**WFT NY LOT LINE CHANGE**

(2014-07)  
979 & 983 NYS ROUTE 32  
Section 2; Block 1; Lots 42 & 46  
RR Zone

**LOT LINE CHANGE**

Date: May 15, 2014  
Time: 7:09 p.m.  
Place: Town of Newburgh  
Town Hall  
1496 Route 300  
Newburgh, NY 12550

SHALLOW SYSTEM DETAIL (2-1-46)  
N.I.S.

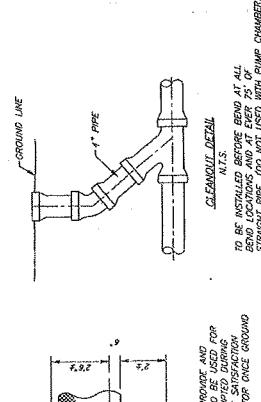
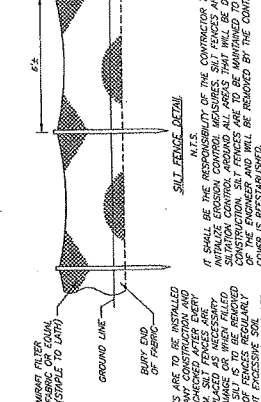
4. The Septic Design Table has been revised.
